# UNITED STATES PATENT AND TRADEMARK OFFICE

APPLICATION NO.	FILING DATE	FIRST NAMED INVENTOR	ATTORNEY DOCKET NO.	CONFIRMATION NO.
10/823,353	04/13/2004	Phillip C. Watts	028058-000110US	4721
20350 7590 02/02/2010 TOWNSEND AND TOWNSEND AND CREW, LLP TWO EMBARCADERO CENTER EIGHTH FLOOR SAN FRANCISCO, CA 94111-3834			EXAMINER MOWLA, GOLAM	
			ART UNIT 1795	PAPER NUMBER
			MAIL DATE 02/02/2010	DELIVERY MODE PAPER

## **FINAL ACTION**

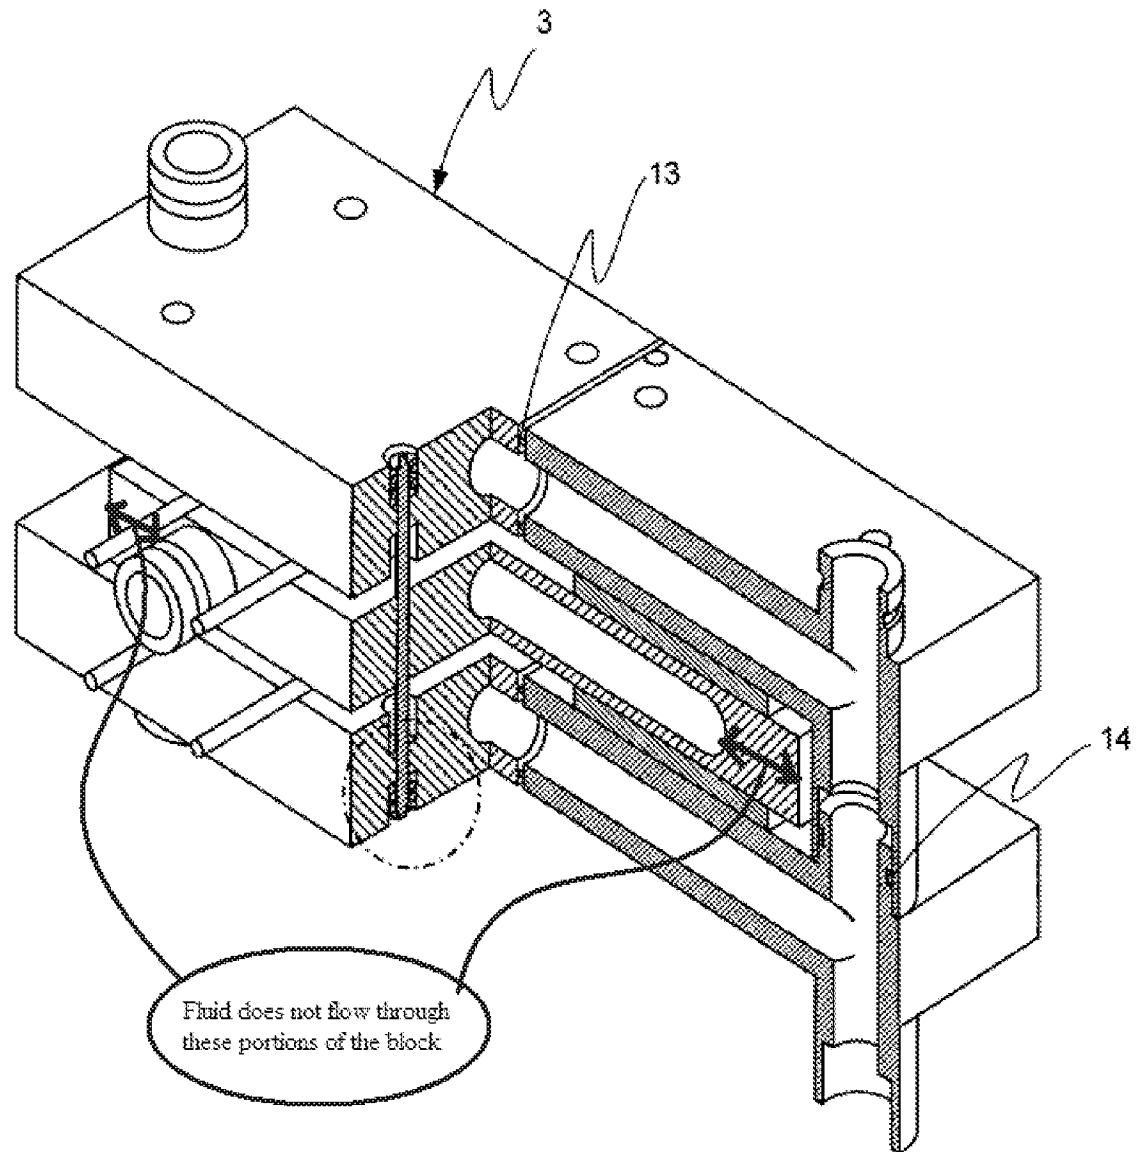
Claim 8 requires the first thermal module to comprise a block including a first passage through which first passage the first fluid flows through the block and that each of the plurality of second thermal modules comprises a respective second block including a respective second passage through which second passage the second fluid flows through the respective second block. However, although the fluid goes from the inlet port to the outlet port, the original specification as filed does not disclose that the first fluid flows through the first block and the second fluid flows through the second block. In order for the first fluid to flow through the first block (hot block 7), the first fluid has to pass from one end of the block 7 to other. See figure below which illustrates the

portions through which the first fluid does not go through. Similar reasoning applies for the cold blocks 1 and 3.
